DOCKET ITEM #9

Master Plan Amendment #2018-0007

CDD Concept Plan #2016-0003

Greenhill / West Alexandria CDD –

PROPOSED
GRADING PLAN -
35' SHIFT - NO
CONNECTION

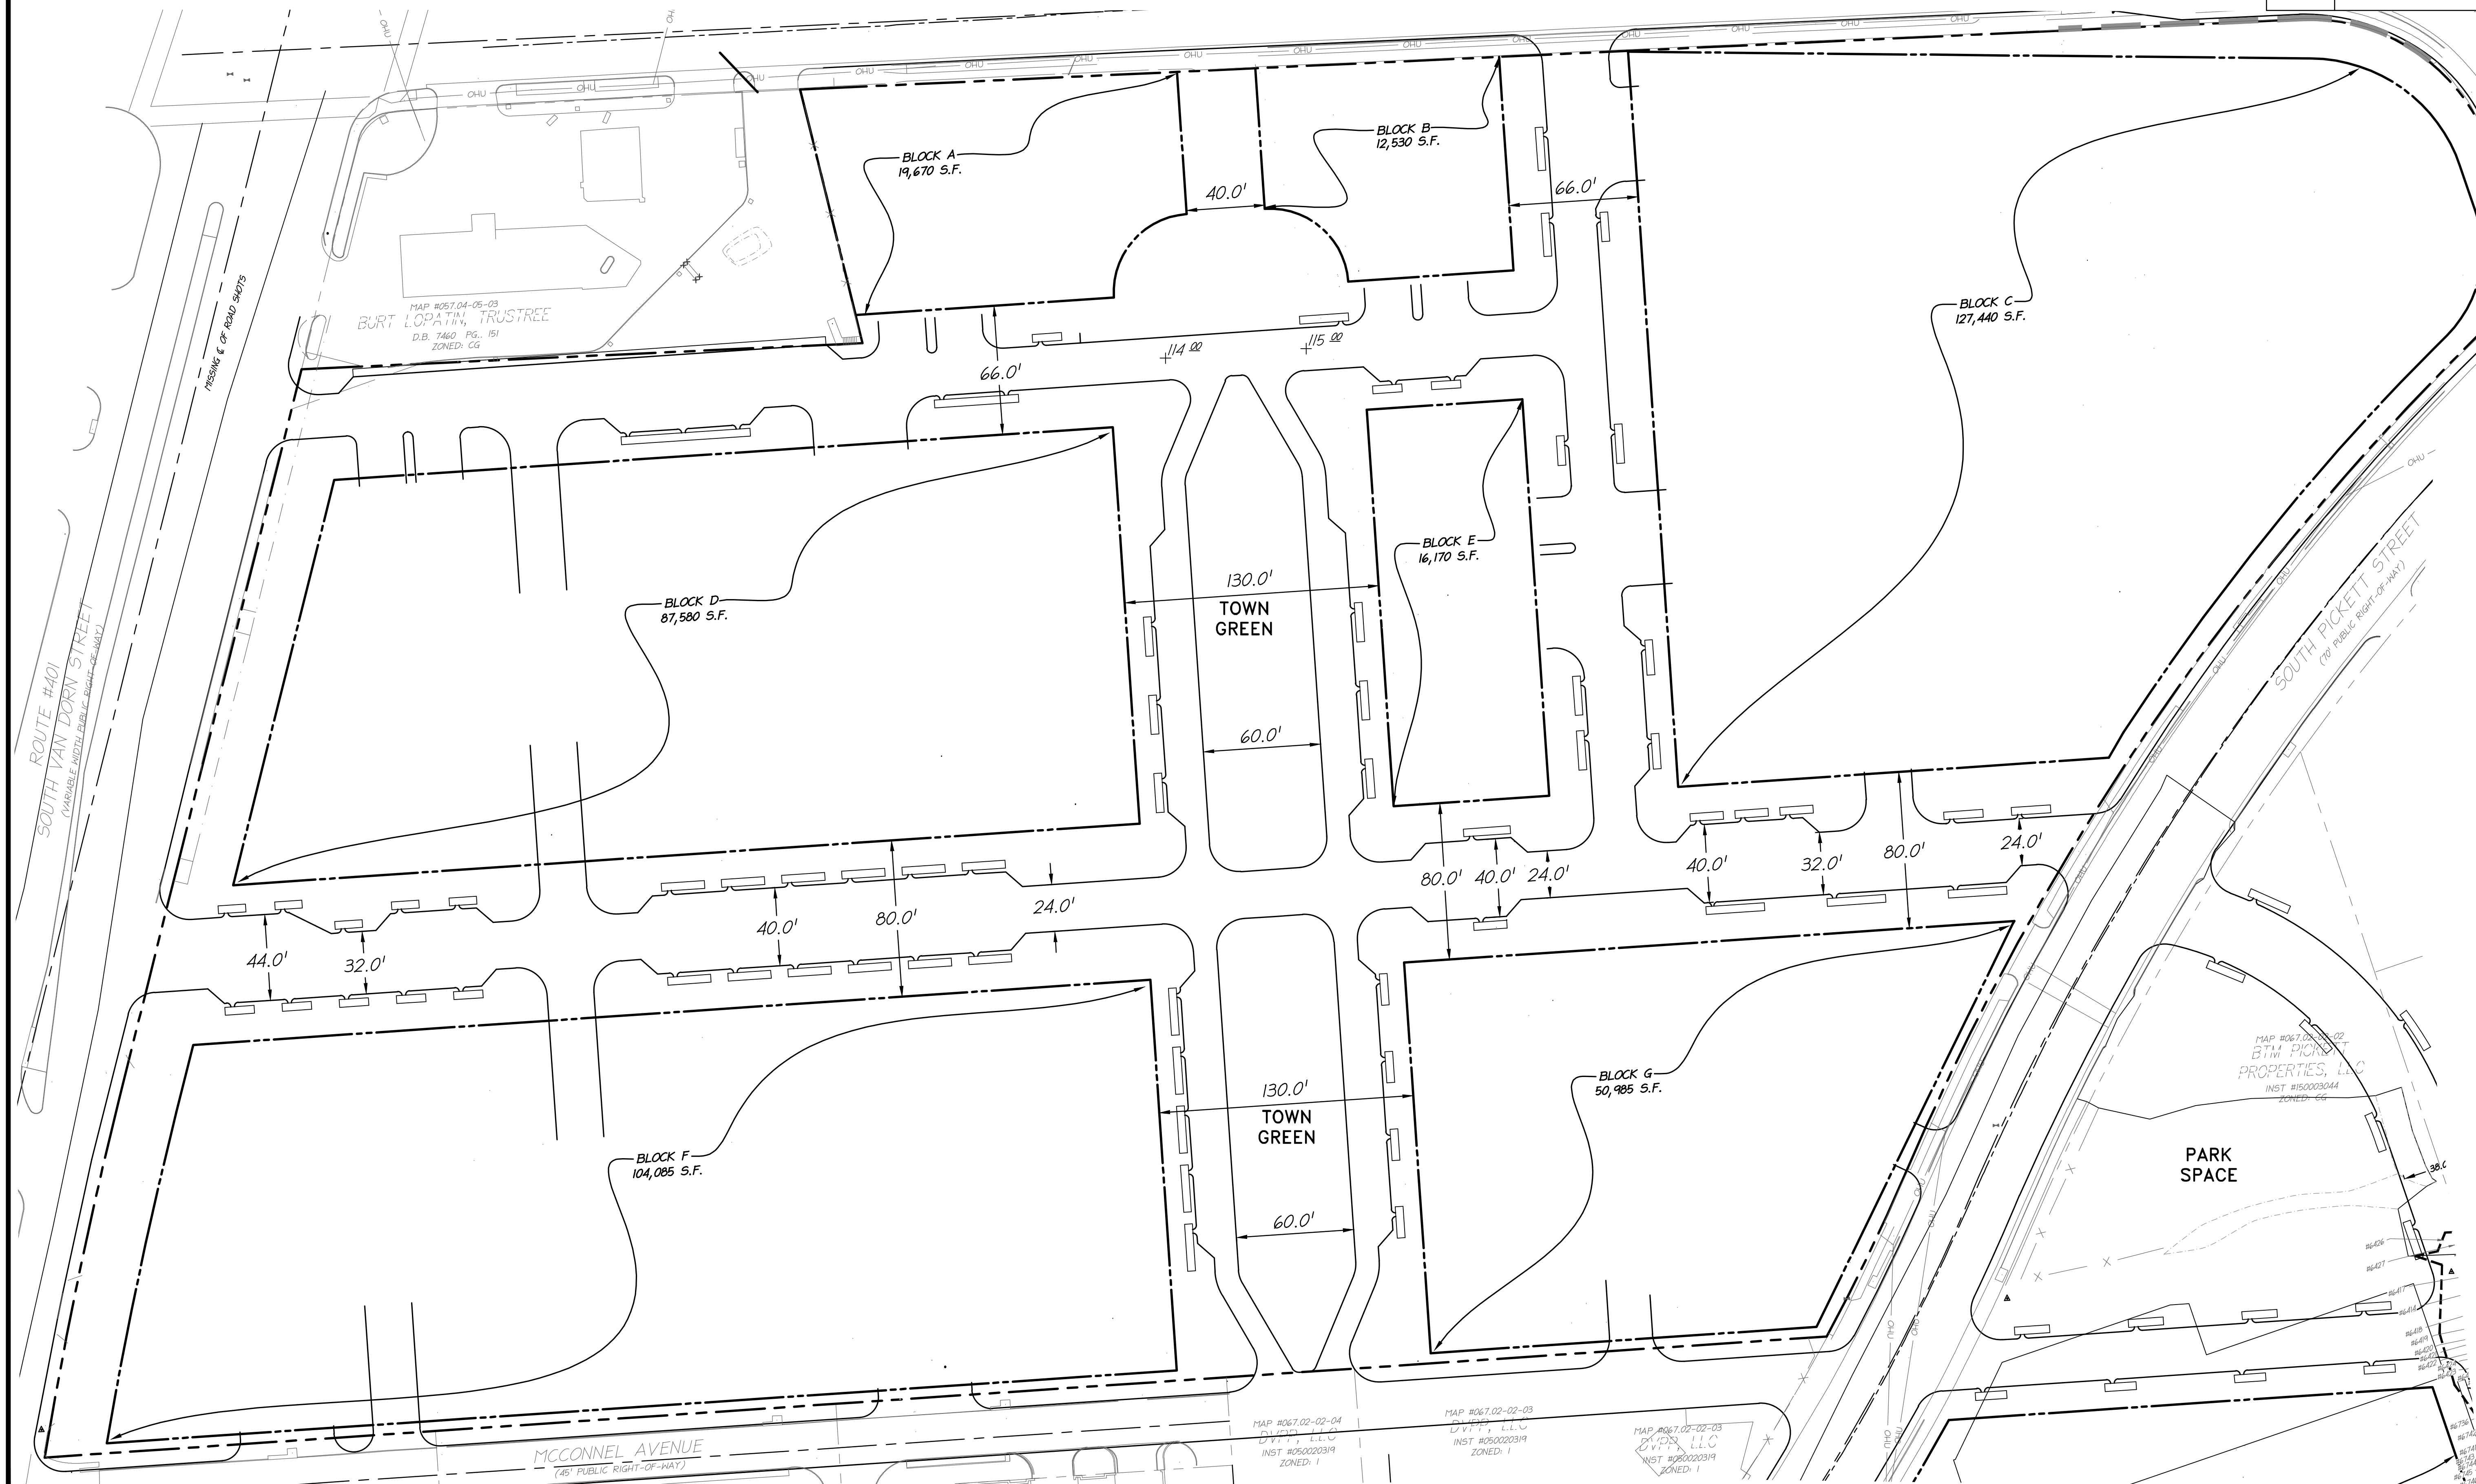
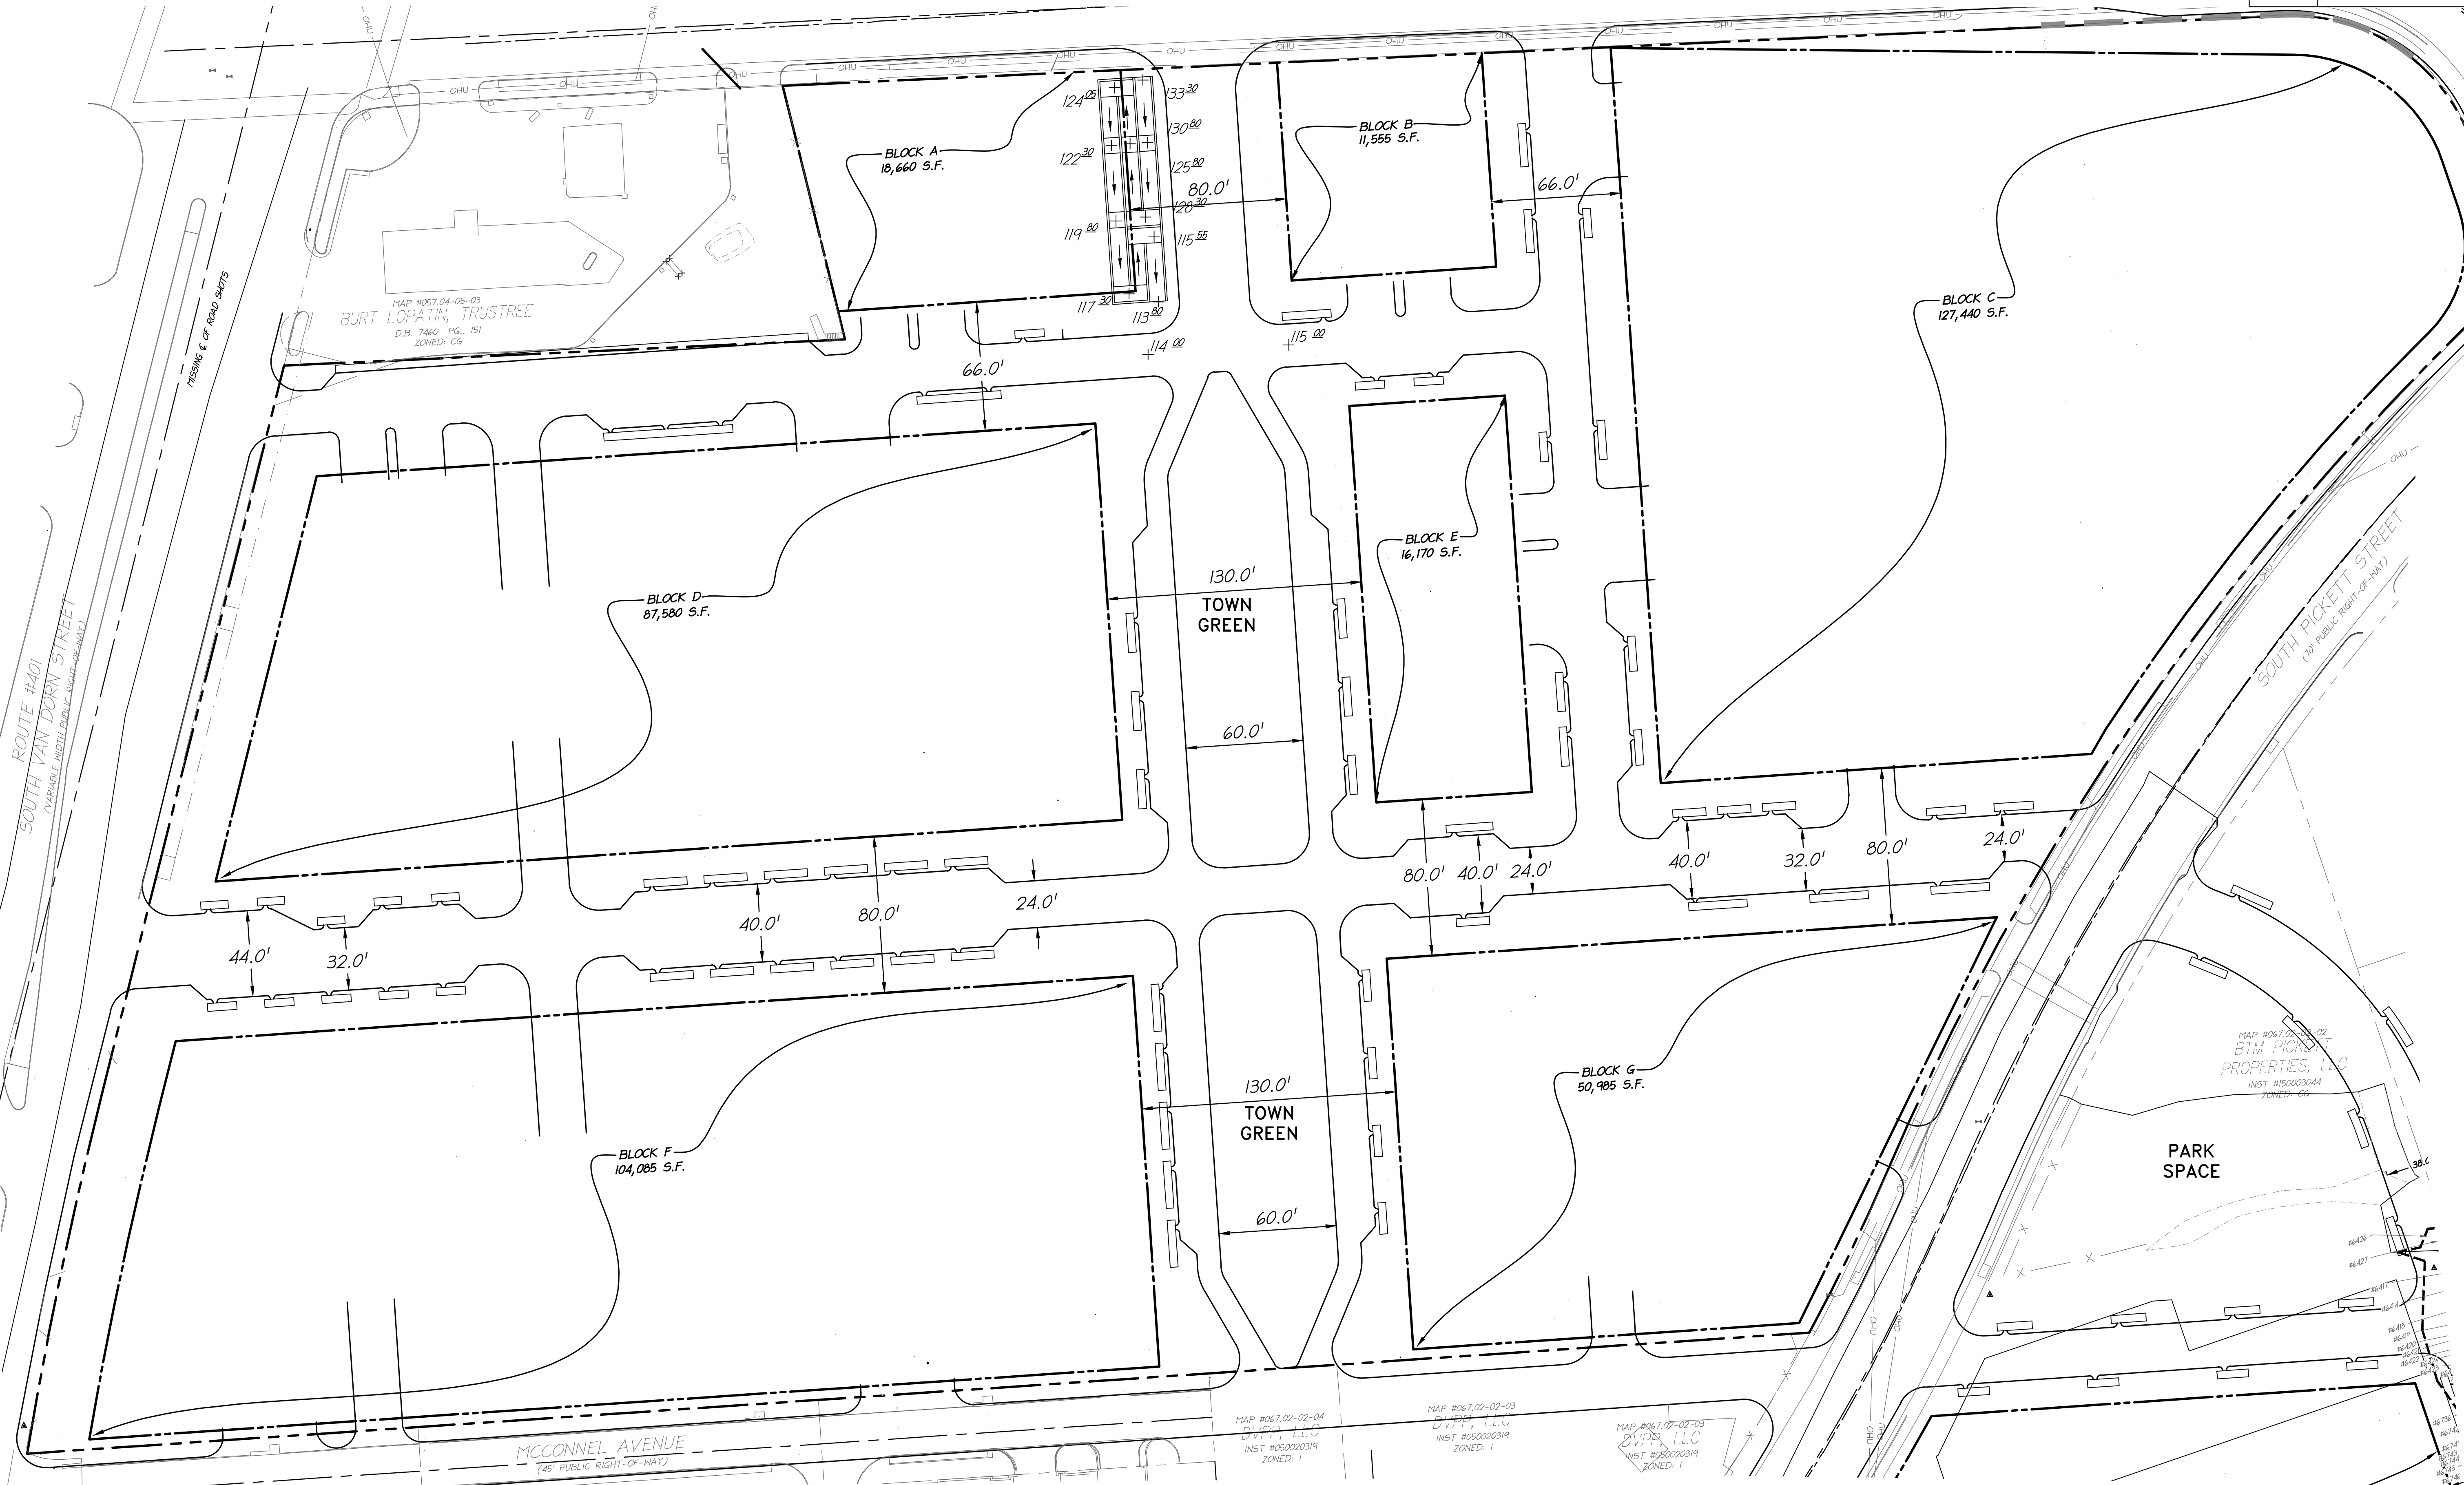
We continue to disagree that it is advisable from an engineering perspective to provide a vehicular connection to Edsall road via Public Street A (the major north-south street). As a result, we did not include the following change: "The reconfiguration of the area between Blocks A and B, now listed as the "Spanish Steps," to allow for a vehicular connection to Edsall Road. The right-of-way width to depict between Blocks A and B would be 80 feet." As you can see on Exhibit 1, attached hereto, we believe the vehicular connection is not advisable for several reasons. First and foremost, the change in grades between Edsall and the new Public Street "B" would cause the slope of that portion of the road to be at 14%, a slope not recommended on a regular basis by the Department of Transportation and Environmental Services. Vehicles coming up that 14% slope to the new intersection would be at a disadvantage moving into the

Finally, staff has recommended in Condition #43 that the applicant provide engineering plans in the future for City staff to determine the feasibility of requiring a vehicular connection to Edsall Road, as part of the public right-of-way for Public Street A, between Blocks A and B on the north-central portion of the CDD Concept Plan area. Planning & Zoning and Transportation & Environmental Services staff view the provision of a north-south vehicular connection through the site as an important planning goal. The street network envisioned for the project site in the Landmark-Van Dorn Corridor Plan specifically depicts the street connecting through from South Pickett Street on the south to Edsall Road to the north. This connection is particularly important from a vehicular traffic perspective given that Public Street A has been designed to potentially align with the northern terminus of the multimodal bridge in the route currently being studied. A vehicular connection to Edsall Road would theoretically allow vehicles to travel from Eisenhower Avenue in a northern direction across the new multimodal bridge and through the project site to Edsall Road without needing to use South Van Dorn Street.
